**PLANNING COMMISSION MEETING**

2. Preliminary Site Plan Review for General Planned Unit Development (GPUD23-001)

Re: Hamburg Village  
Preliminary Site Plan Review #2

**To:** Planning Commissioners  
**From:** David Rohr  
Hamburg Township  
Township Planner  
**Date:** December 20, 2023  
**Agenda Item:**  
**Project Number:** Preliminary Site Plan Application for General Planned Unit  
Development (GPUD23-001)  
**Project Location:** 76200 M-36 and 10303 Hamburg Road  
**Owner:** Ronny Hamama  
**Applicant:** Ronny Hamama

**UTILITY PLAN**  
SCALE: 1" = 30'

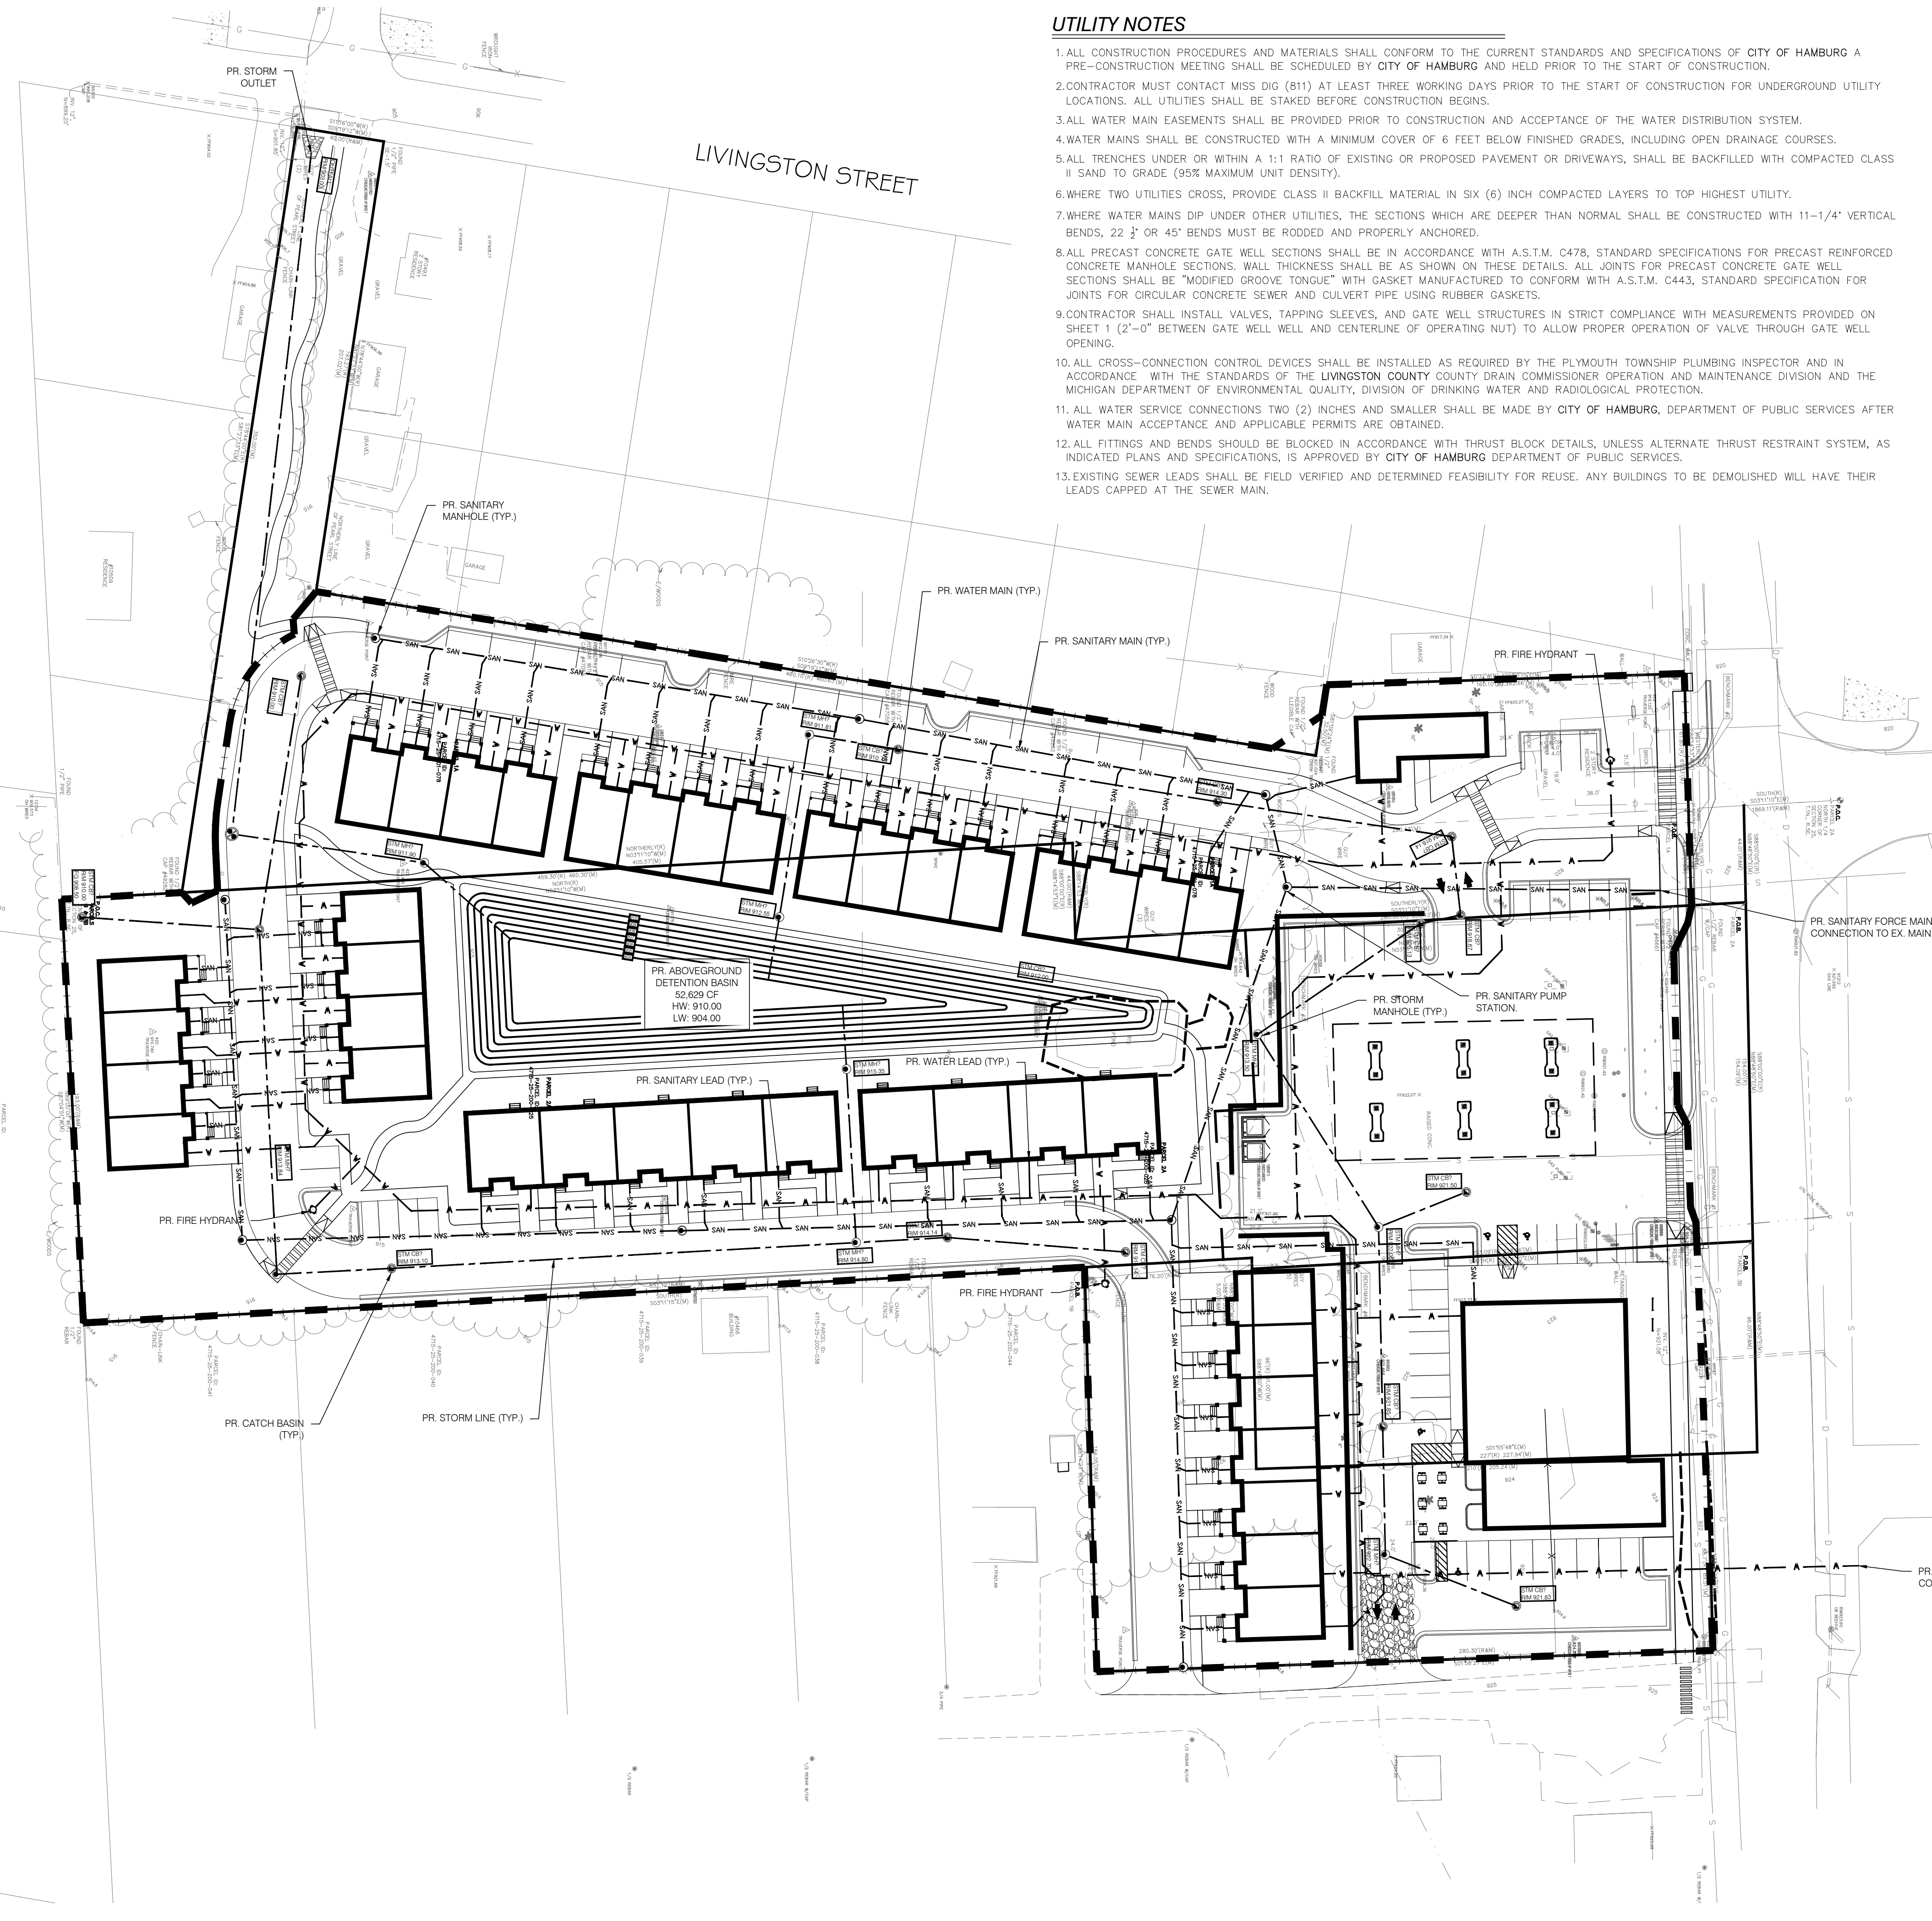
6. Incorrect municipalities are referenced in the General Notes on Sheet C.5.
7. The utilities in general should be laid out parallel to the proposed roadways, most notably on the north/ south roadways.
8. The scale on Sheet C5.0 is incorrectly listed.

1 Site Plan  
SCALE: 1" = 40'

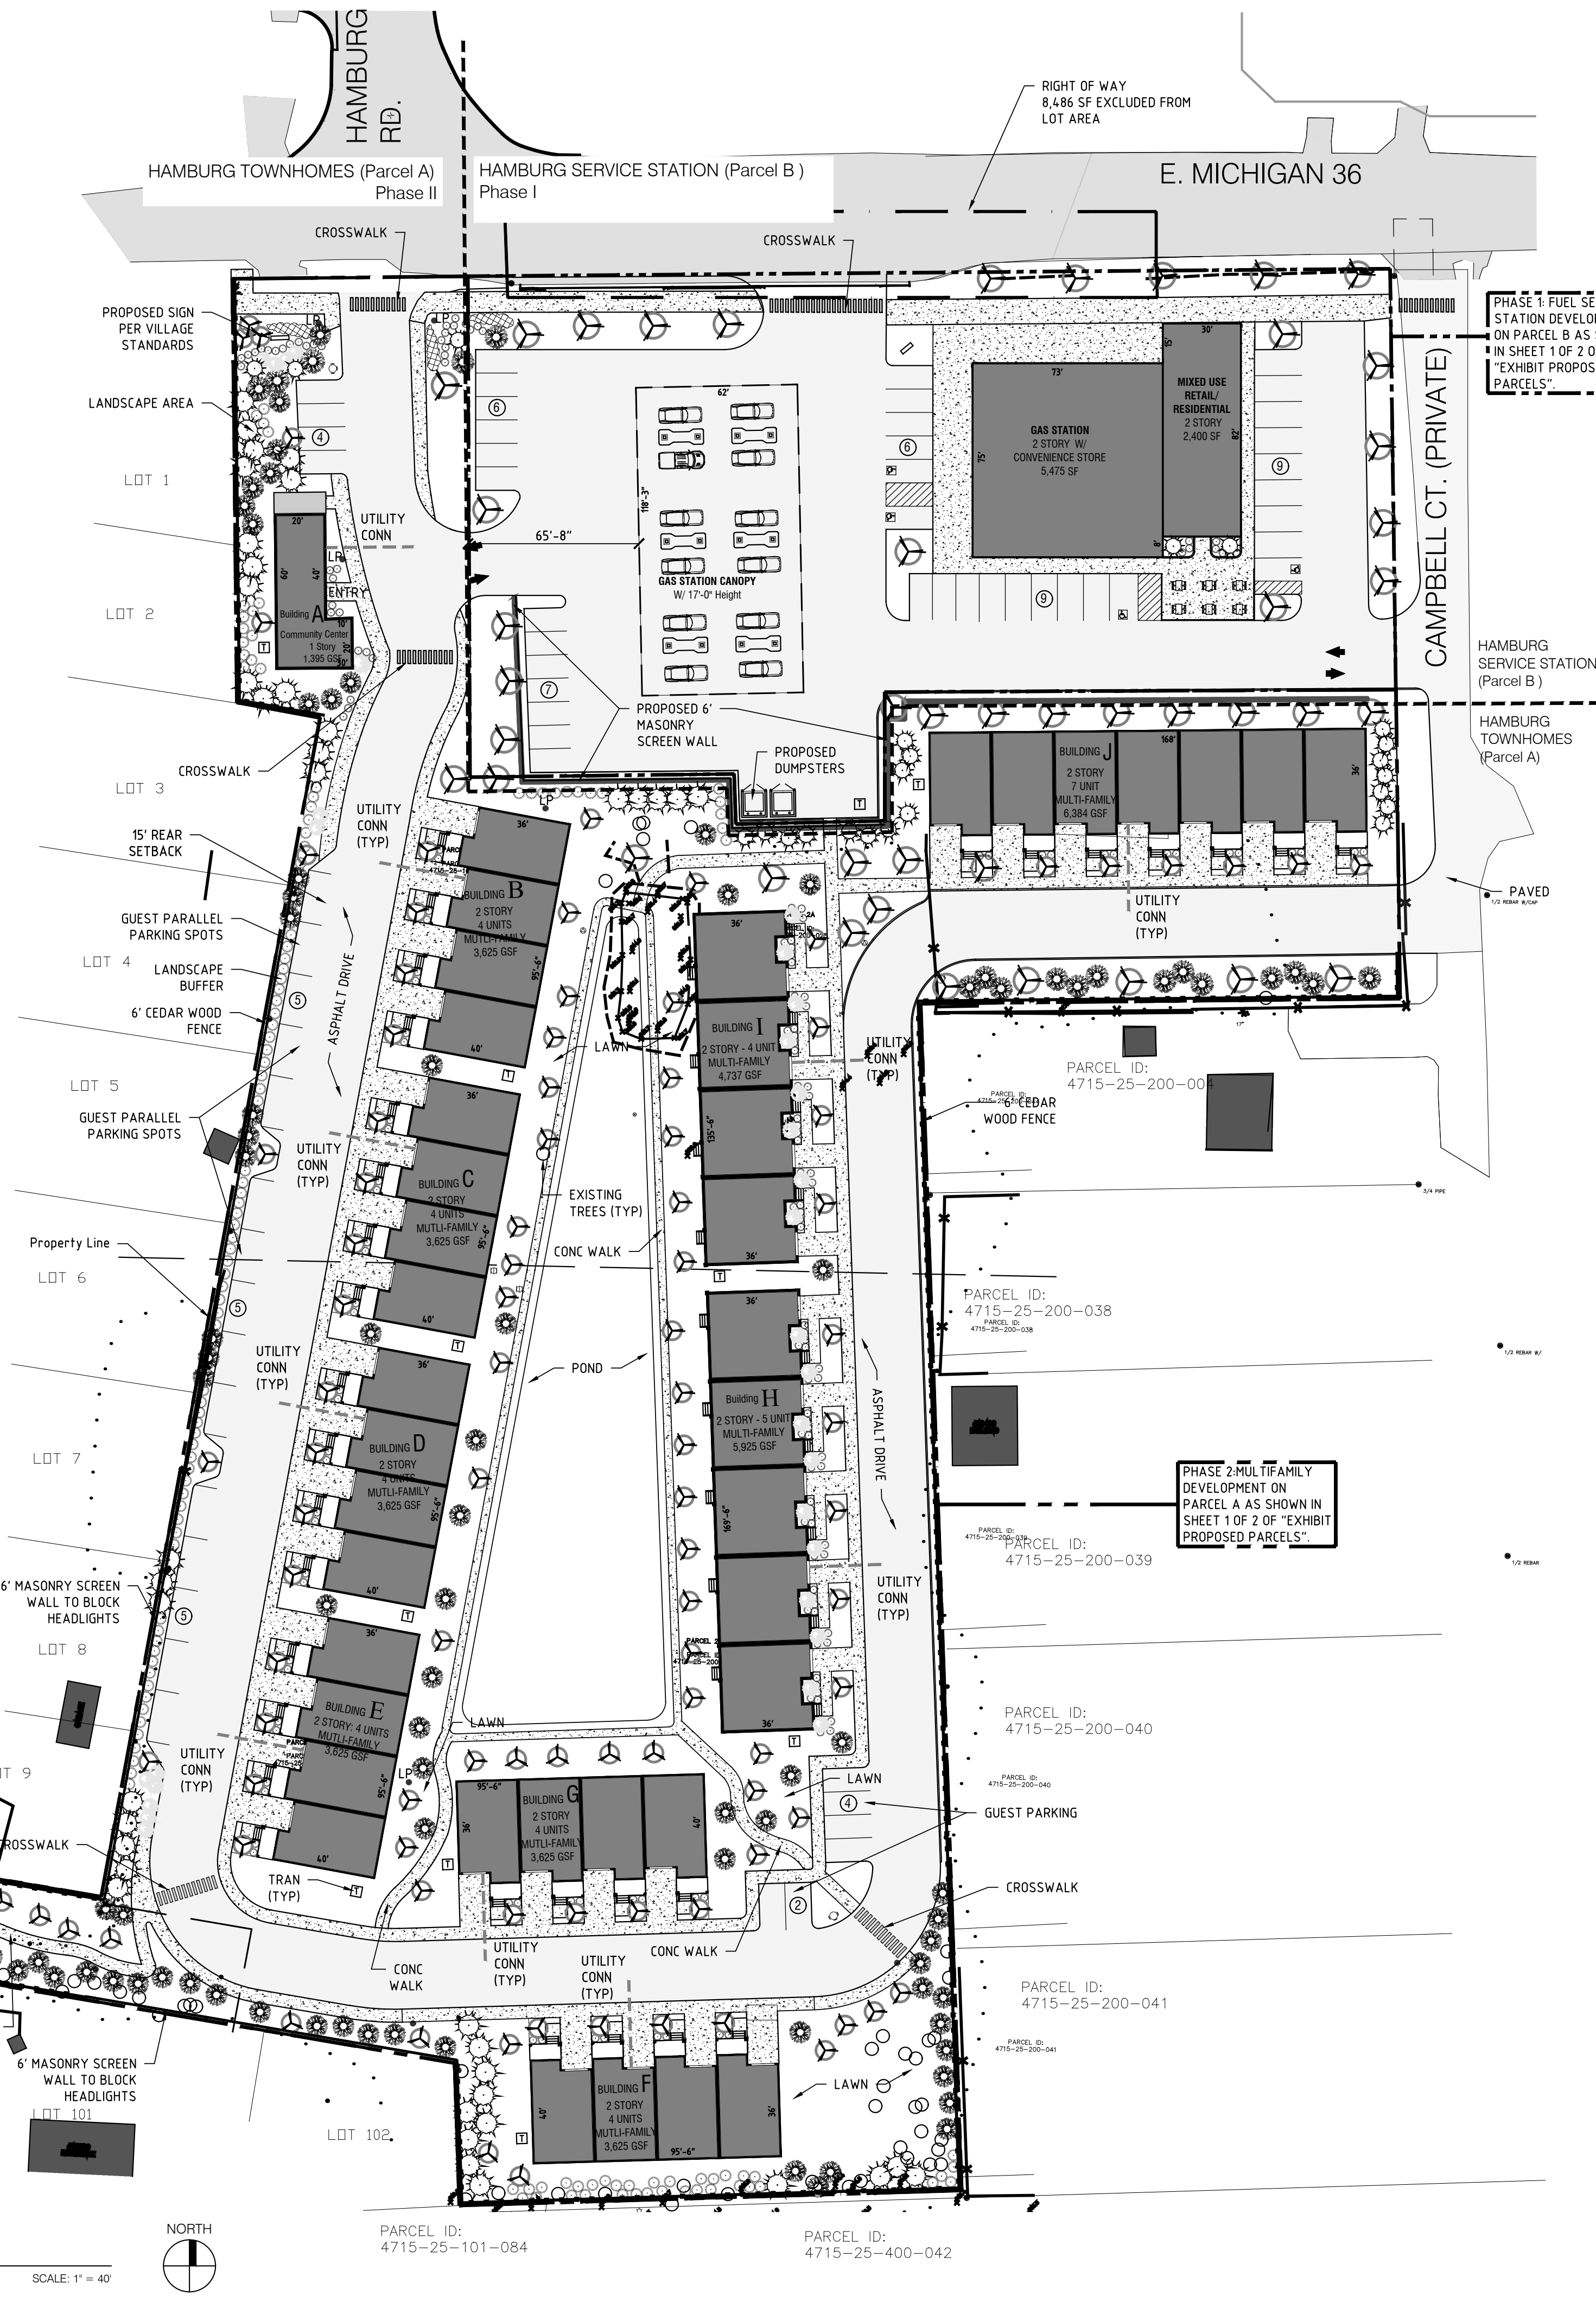
**Table 1** (Sheet AS1.00 Site Plan)

022065  
L101

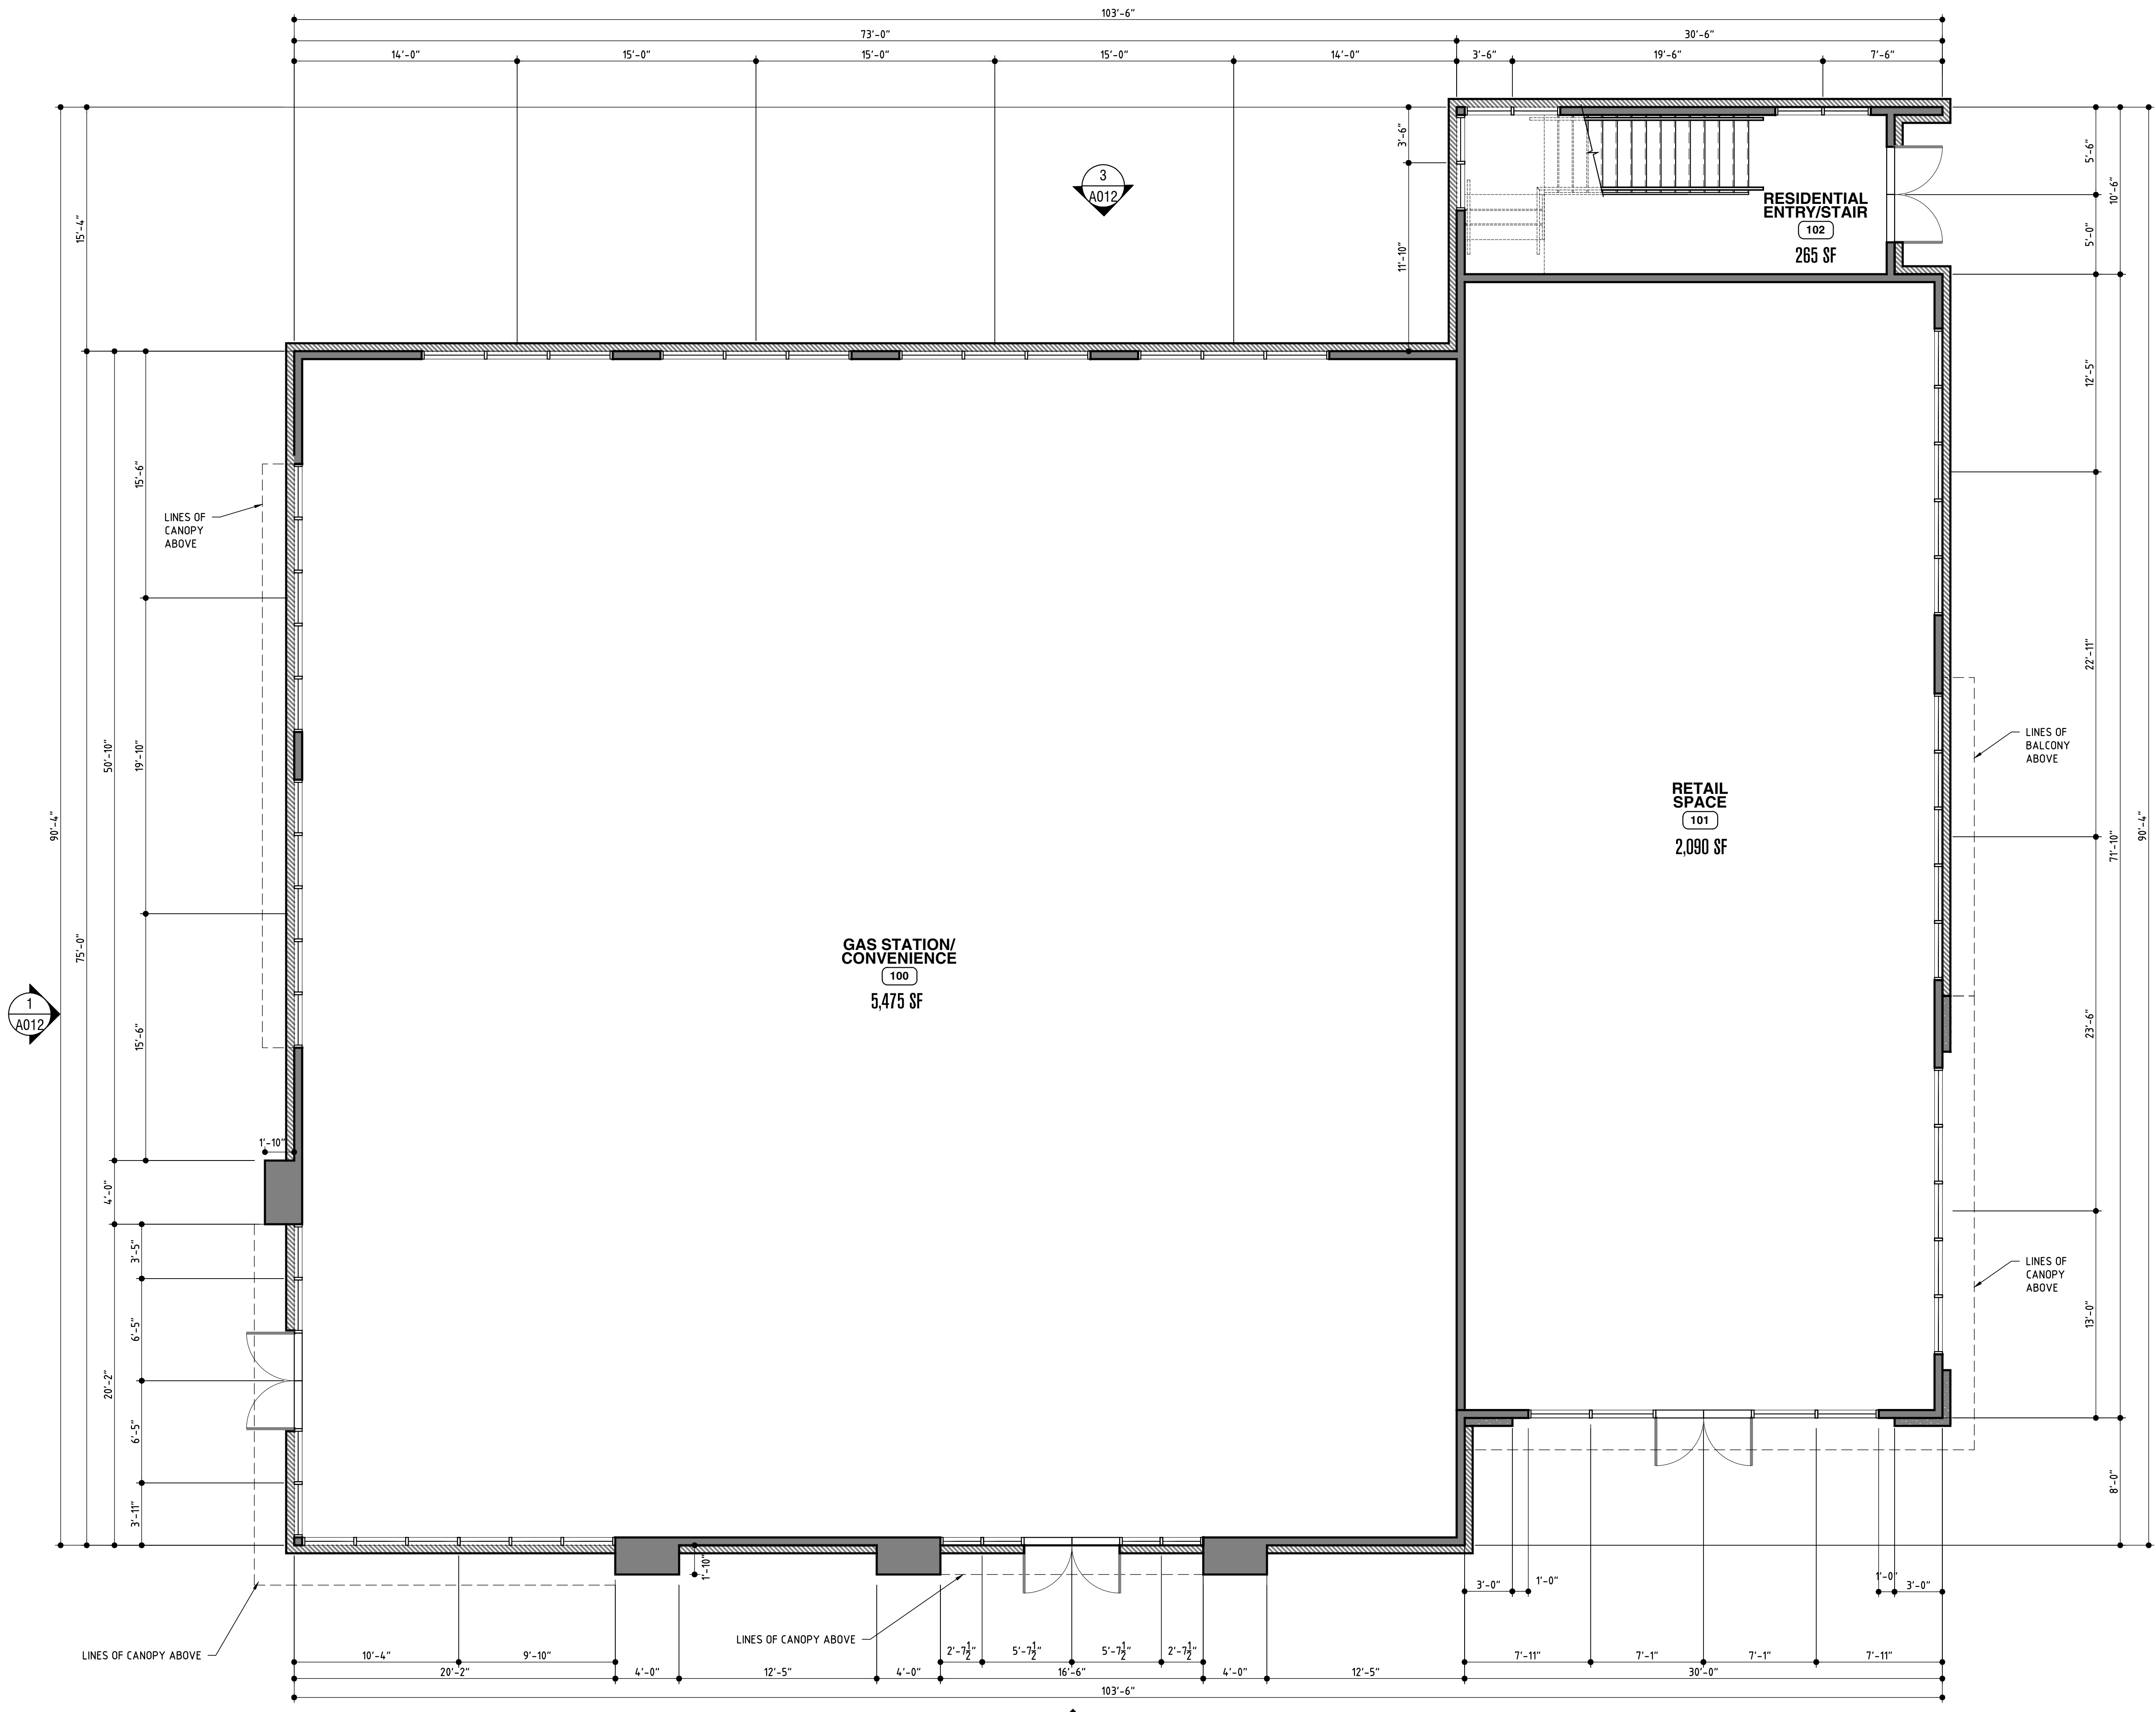
Plan Page L101: Landscape Plan shows conceptual landscaping including the existing trees to remain and proposed new trees.

The landscaping plan details two buffer areas: west and south. Both proposed buffers provide more landscaping than is required. The entire site (sans M-36) is wrapped in a 6' wooden fence.

Little detail is provided for the M-36 or Campbell Ct. frontages. A more detailed plan would be useful for the final site plan review.

A more detailed landscaping plan that meets all the requirements. Applicant may also specify which landscaping requirements they wish to have waived.
